January 11, 2011

**REPORT
ON
THE *VIA VERDE* PROJECT OF THE ELECTRIC ENERGY AUTHORITY
TITLED *GASODUCTO* DE PUERTO RICO: A TECHNICAL EVALUATION**

**Submitted to:
Mr. José M. Rosado
Deputy District Engineer for the Antilles
Chief Antilles Regulatory Section
US ARMY CORPS OF ENGINEERS
Jacksonville District
400 Fernandez Juncos Avenue
San Juan, Puerto Rico 00901-3229**

Figure 1. Map of the Gas Line, "Gasoducto" Project extending for 91 miles from Costa Sur electric plant in Penuelas to Arecibo and then east to Guaynabo. The gas line is a 24 inch steel pipe located at a depth of 5 feet below the ground surface as shown in the cross section presented above.

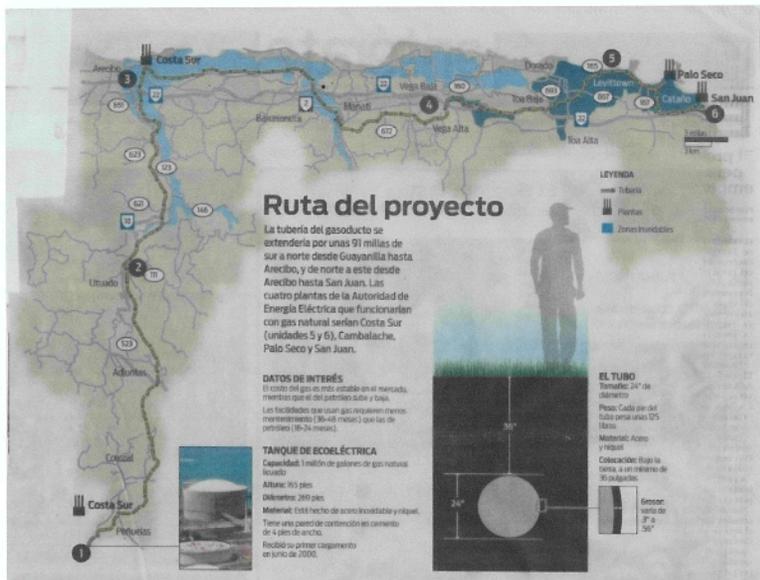
b- From our assessment of the documents submitted by the agency they lack scientific studies of geotechnical engineering, general engineering drawings and construction specifications required for bidding, plans including longitudinal profiles, sections, technical design, including classification of soil to be used as fill material, the compaction of the soil around and beneath the steel pipe. From the document of the DIA-P prepared by DIVISION DE PROTECCION AMBIENTAL Y CONFIABILIDAD DE CALIDAD Y ASESORES AMBIENTALES Y EDUCATIVOS, we downloaded 24 topographic maps with the route of the gas line pipe at a certified scale of 1:20,000. We found in the documents great error in the scales of the topographic plans. Also 13 google earth maps with the route of the gas line pipe drawn were obtained from the DIA-P.

1. The "Gasoducto" or VIA VERDE project as presented without a complete set of engineering construction plans and specifications is not sound from the engineering point of view and acceptable for bidding and construction purposes.
2. The excavation of a 5 feet depth trench in an irregular and variable longitudinal profile is improper and incorrect.
3. The scale of 1:20,000 certified in each of the submitted topographic maps of the DIA-P is incorrect.
4. The elevation of the terrain along the route varies from 1 to 1010 meters.
